Project
Newsome Ponds, Huddersfield

Title
Existing Pond Sections sheet 2

Project number	Originator	Volume	Level	Type	Role	Drg. No.	Rev.
24.21001-ACE-ZZ-ZZ-DR-S-3006							P3

S2 Existing Pond Section 2
1 : 50

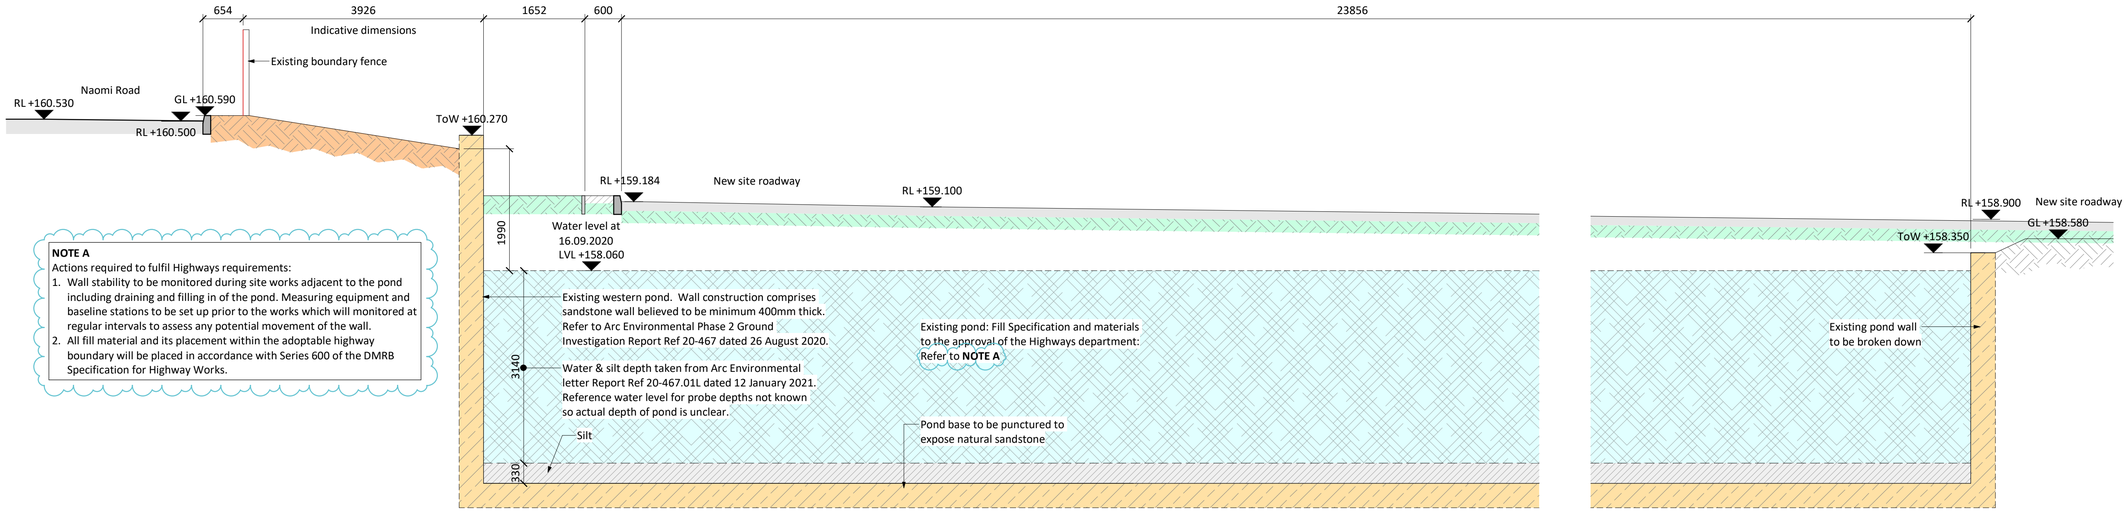
NOTE A
Actions required to fulfil Highways requirements:
1. Wall stability to be monitored during site works adjacent to the pond including draining and filling in of the pond. Measuring equipment and baseline stations to be set up prior to the works which will monitored at regular intervals to assess any potential movement of the wall.
2. All fill material and its placement within the adoptable highway boundary will be placed in accordance with Series 600 of the DMRB Specification for Highway Works.

S3 Existing Pond Section 3
1 : 50

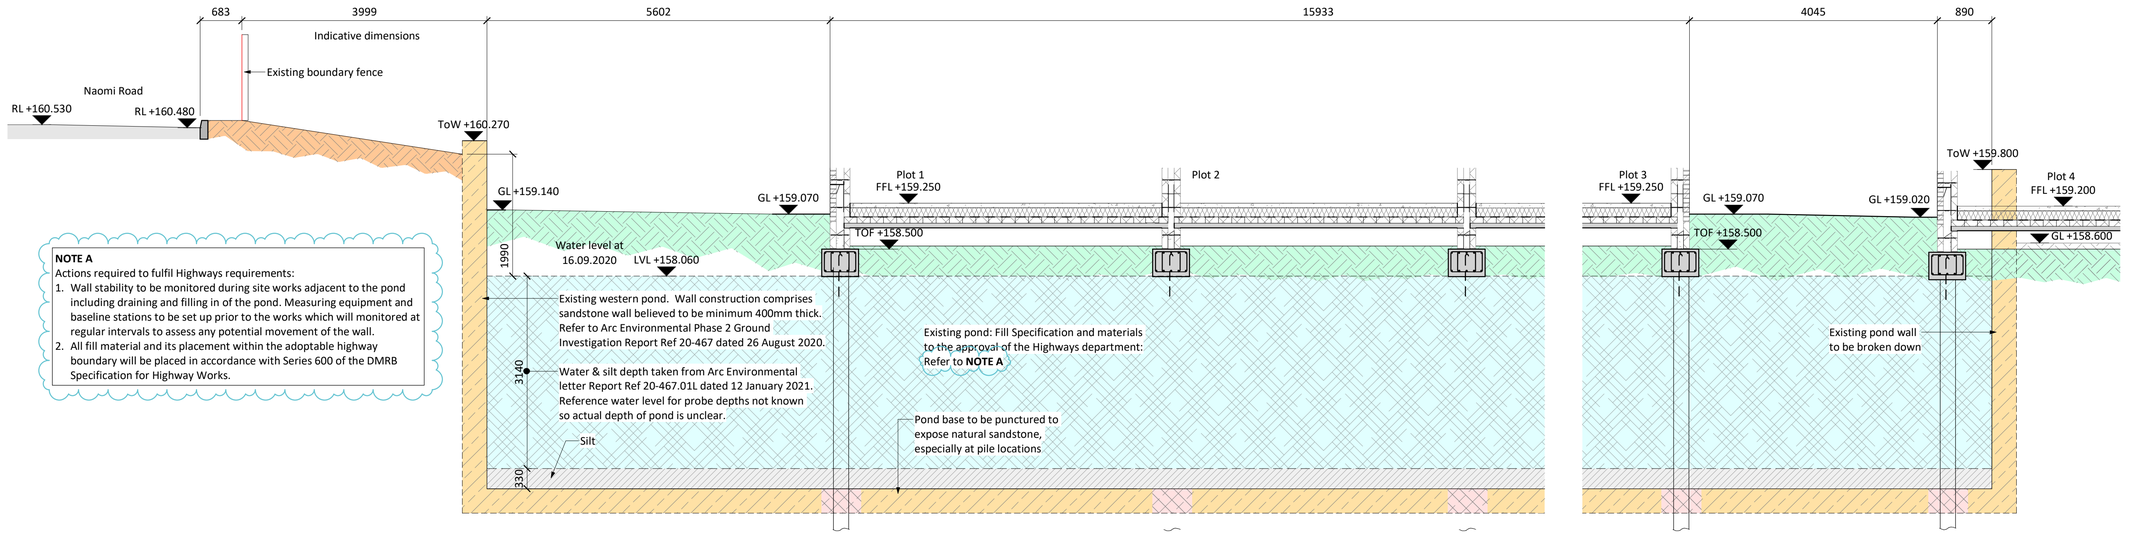
NOTE A
Actions required to fulfil Highways requirements:
1. Wall stability to be monitored during site works adjacent to the pond including draining and filling in of the pond. Measuring equipment and baseline stations to be set up prior to the works which will monitored at regular intervals to assess any potential movement of the wall.
2. All fill material and its placement within the adoptable highway boundary will be placed in accordance with Series 600 of the DMRB Specification for Highway Works.
